## Stage 1 Quality Audit

Blackpitts Residence

100114189DG0001

# BLACKPITTS STUDENT HOUSING

**Figure 3-1 – Disabled Parking Arrangement**

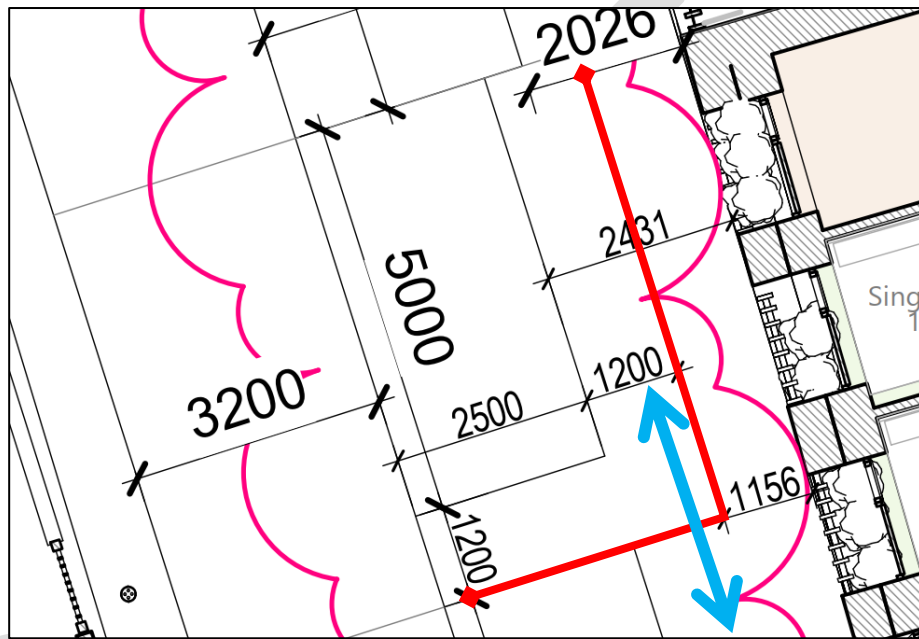
The 1200mm disabled parking access zone – intended to provide clear space for users to enter/exit vehicles – is proposed to be painted onto the footpath. This reduces the effective width of the footpath and creates conflict between disabled users and pedestrians. This may lead to conflict between both, especially for visually impaired users.

The Design Team should adjust the arrangement such that the conflict is mitigated or removed between disabled users and pedestrians.

**Figure 3-2 – Uncontrolled Pedestrian Crossing**

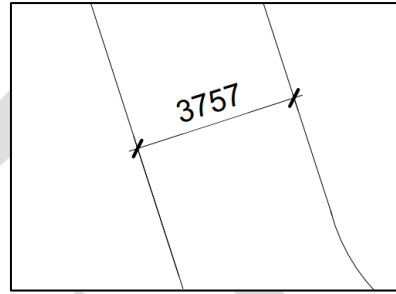
An existing uncontrolled pedestrian crossing is present at the junction of Donovan Lane and Blackpitts. The drawings indicate the proposed narrowing of the existing carriageway however they do not detail provision of a new or amended pedestrian crossing. The absence of a crossing on this pedestrian desire line may lead to the risk of pedestrians entering the carriageway without warning and when not safe to do so, which may result in conflict with drivers.

The Design Team should include for a new or amended uncontrolled crossing with the necessary tactiles and dished kerbing to facilitate safe crossing of the carriageway for pedestrians.

**Figure 3-3 – Vehicle Entrance Turning Movements**

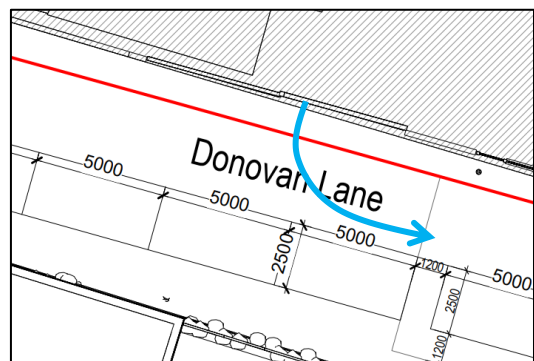
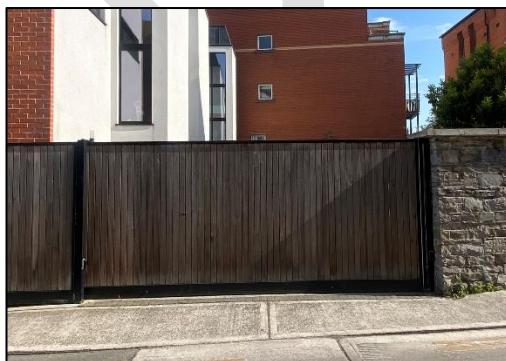
An existing vehicular entrance exists opposite the proposed build out and parking spaces. Due to the proposed reduction in carriageway width, this may result in inadequate turning radii for vehicle ingress/egress which may lead to the risk of side swipe collisions with parked vehicles or conflict with cyclists using the carriageway.

The Design Team should conduct a vehicle tracking analysis to ensure that adequate clearance exists for vehicle turning movements.

**Figure 3-4 – Service Entrance**

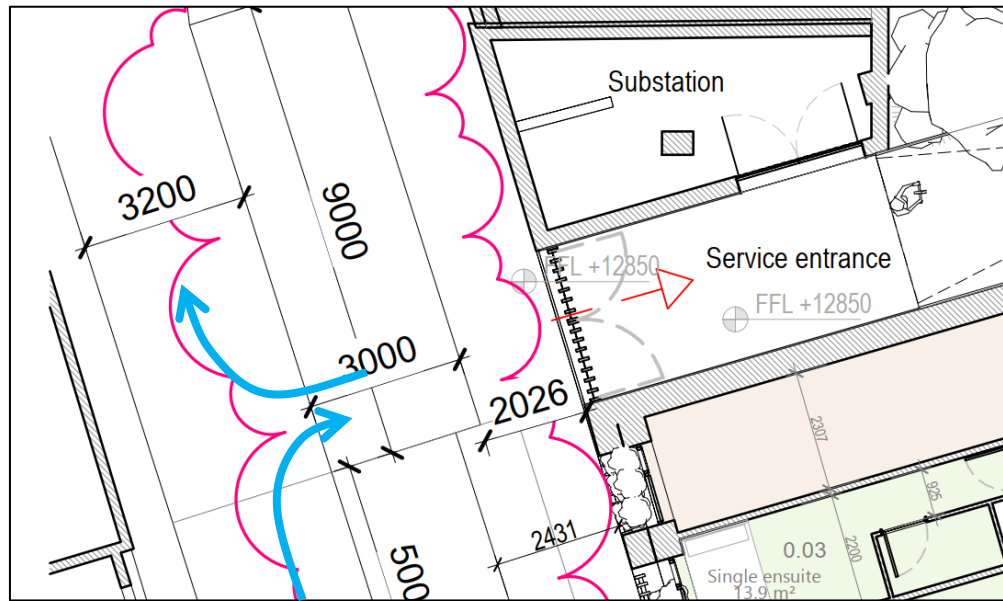
A proposed service vehicle entrance is located behind a proposed loading bay and adjacent to a disabled parking space. This arrangement may result in the service entrance being blocked or inadequate turning radii for service vehicles which may result in side shunt / swipe collisions between vehicles.

The Design Team should provide for a yellow box in front of the service vehicle entrance and should conduct vehicle tracking analysis to ensure adequate clearance exists for vehicle turning movements.

Figure 4-2 - Possible Pinch Point

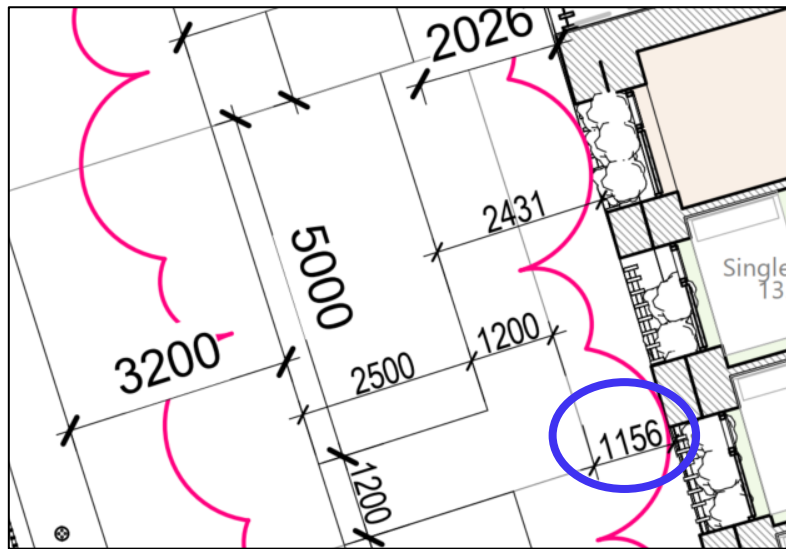
The intention of the proposed 1200mm disabled parking access zone requires clarification. Depending on how the 1200mm access zone is proposed to be marked out onto the footpath, this may create a the impression of pinch point for pedestrians walking along Donovan Lane.

The Design Team should design the proposed disabled parking access zone such that it does not create the impression of a pinch point for pedestrians along Donovan Lane.
